Aman Fashions & Designs Ltd. (Extension)

Nalam, Mirzanagar, Asulia, Savar, Dhaka.

2 November 2023

Socks & Tights Shed:

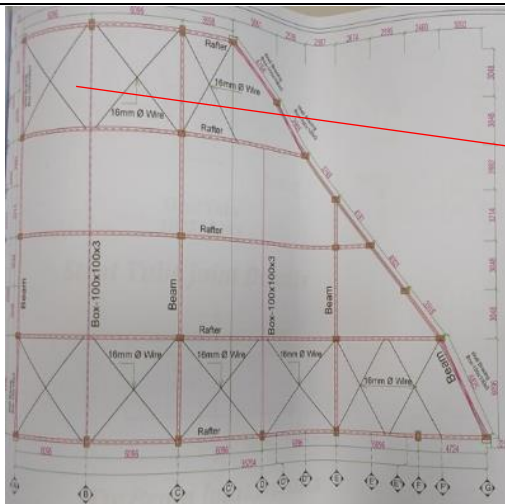
Observation-1: Lack of design report.

Description: As per BNBC, every building or structure designed shall have its design documents prepared in accordance with the provision of Section 1.9.1. The design documents shall include as built drawings and a design report which shall be prepared in compliance with section 1.9.1, part-6 of BNBC.

During inspection, the design report was not available on site. The building engineer is required to prepare a design report based on in-situ material strength & software-based analysis and submit it to RSC for review.

Observation-2: Discrepancies in as built drawings.

Description: During inspection, mismatches were found between onsite condition and as-built drawing. Horizontal bracing missing is as built condition. The building engineer is required to survey the full structure and produce accurate as-built drawings.
